PROJECT: NEC of Buffalo Drive + Oakley Boulevard

| <b>SUBJECT:</b>                                                            | Drainage Study for:<br><b>Buffalo / Oakey Residential Development</b> | <b>COPIES TO:</b><br>Triton Engineering                                                           |

**ADDENDUM#1**  
TO THE  
**TECHNICAL DRAINAGE STUDY**  
FOR  
**Buffalo/Oakey**  
**Residential Development**

Subject: Addendum #1 to the Technical Drainage Study for  
Buffalo and Oakley  
DS 4671A

DR HORTON  
BUFFALO / OAKLEY  
GRADING PLAN

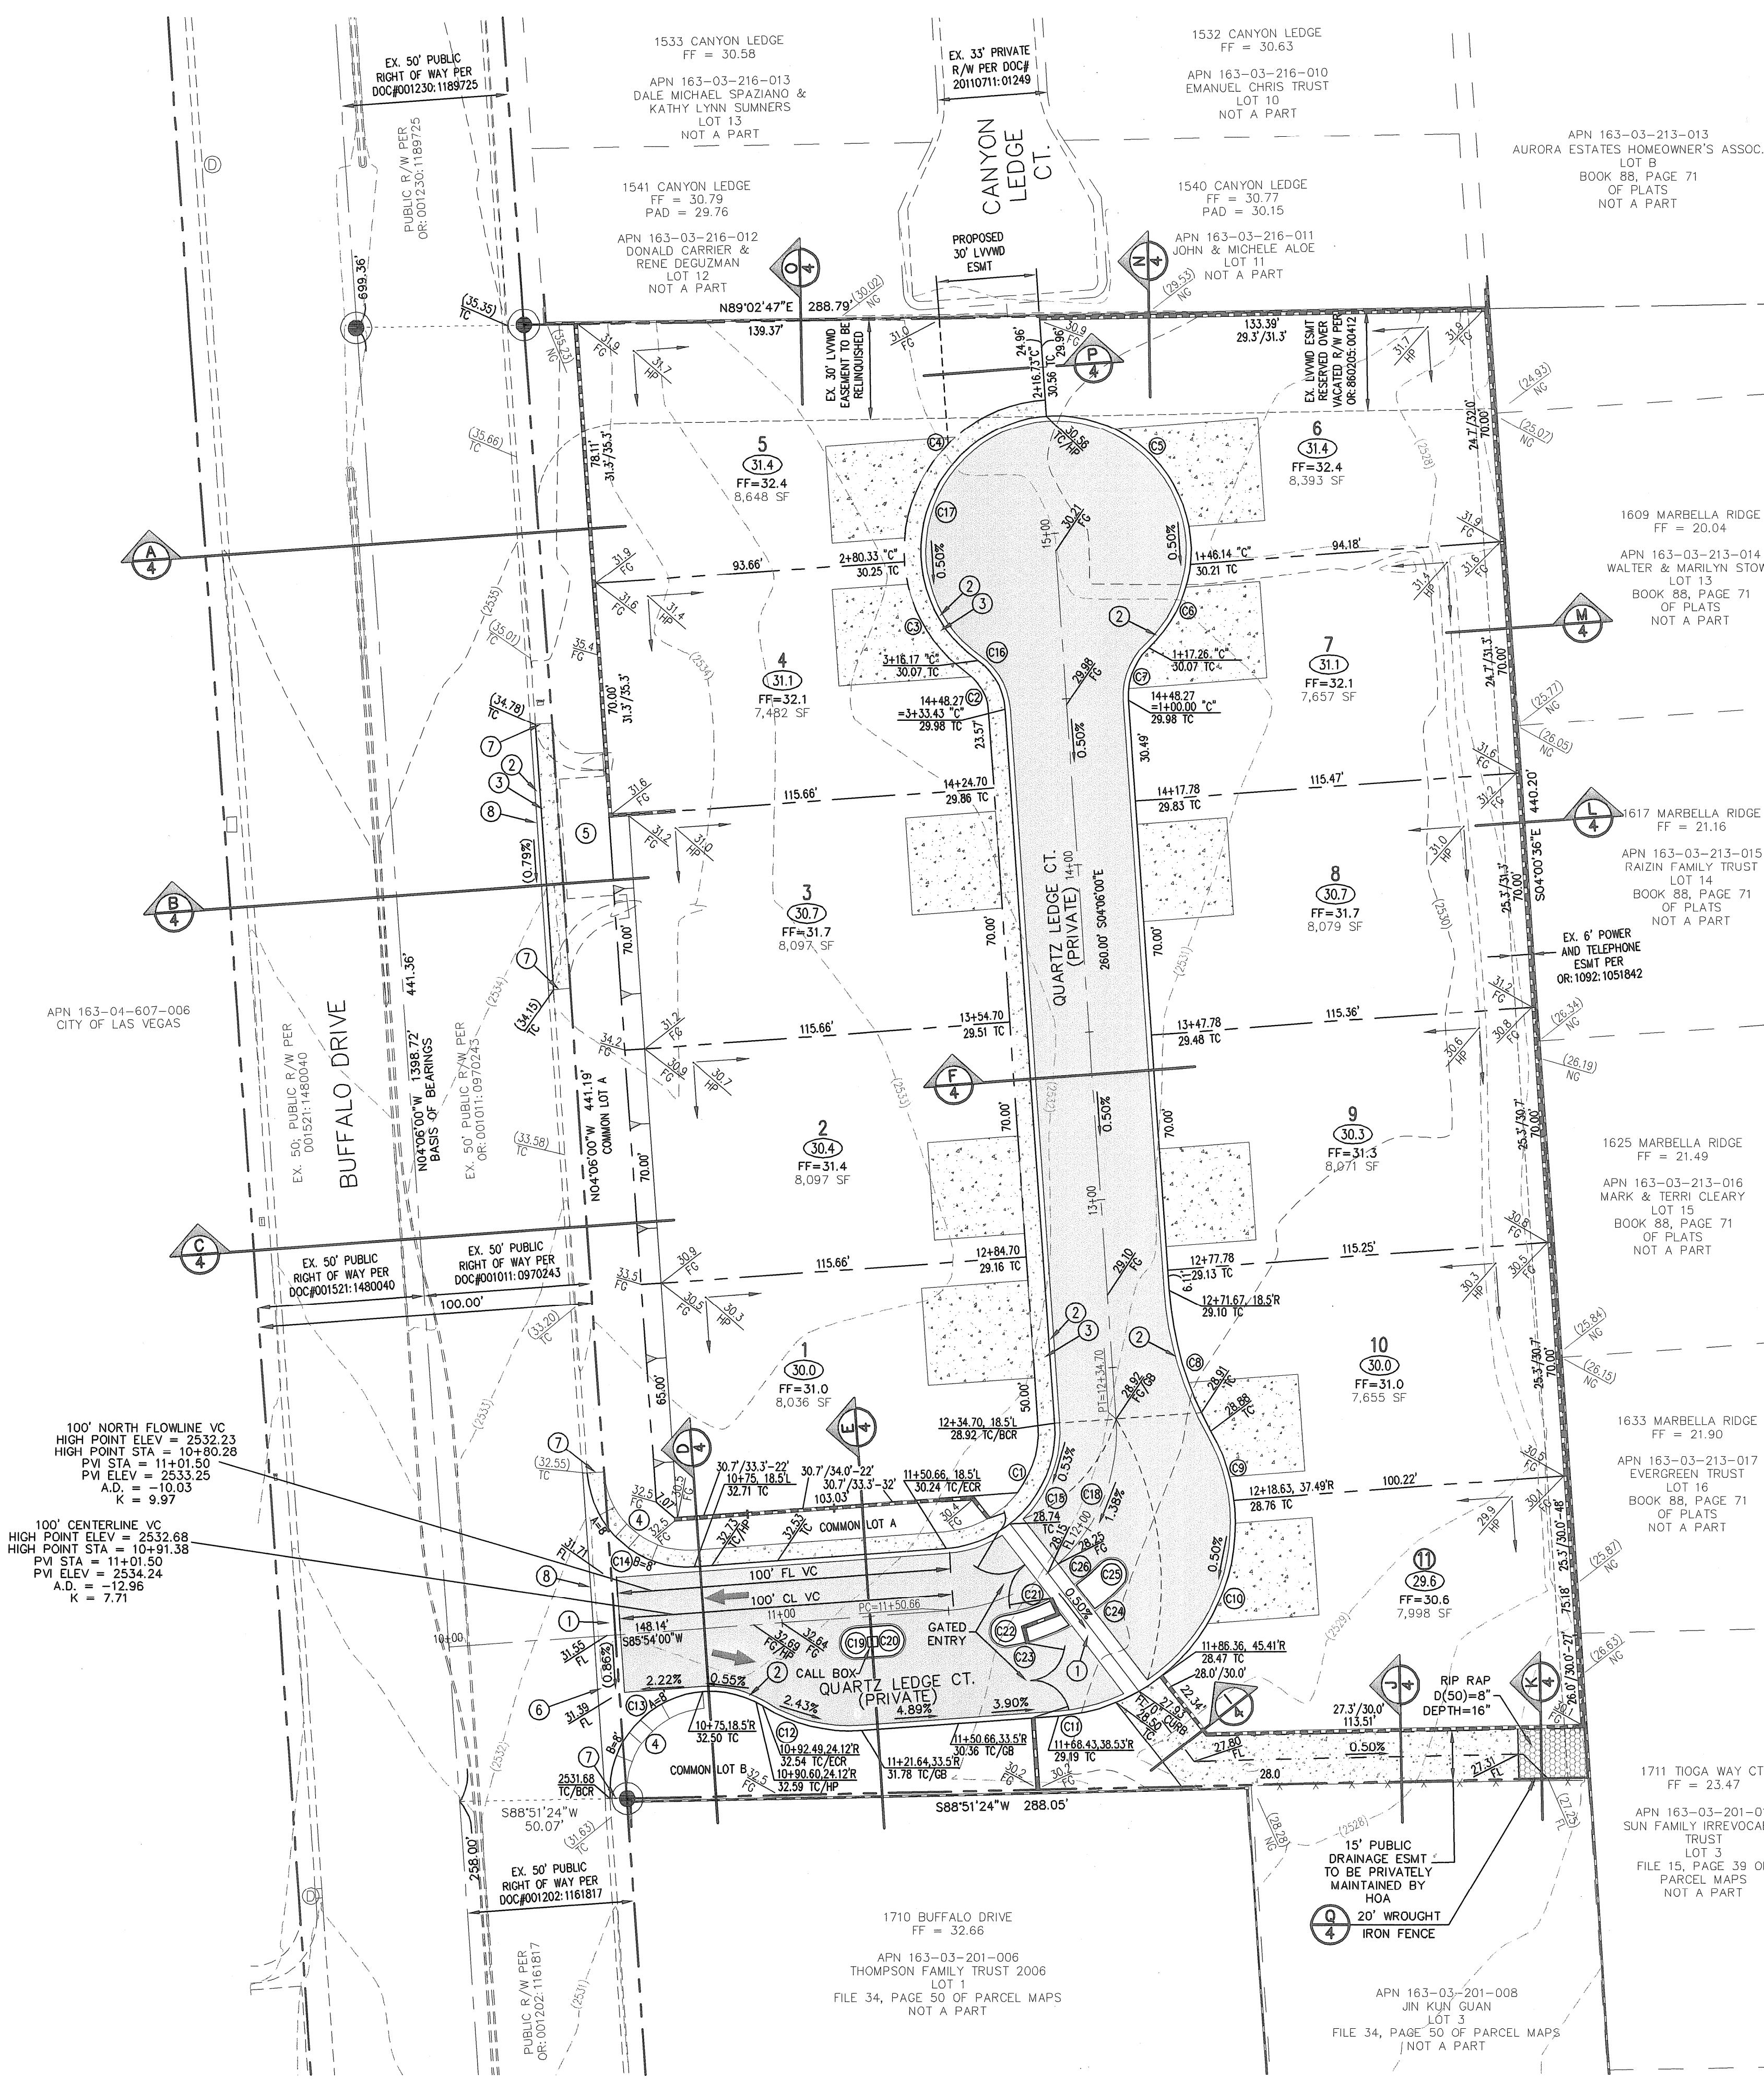
1. Reduce the length of the riprap pad at the end of the proposed public drainage easement at the southeast corner of the development to 10' instead of 20'.

2. Label clearly on the grading plan that the proposed drainage easement is also a "COMMON LOT".
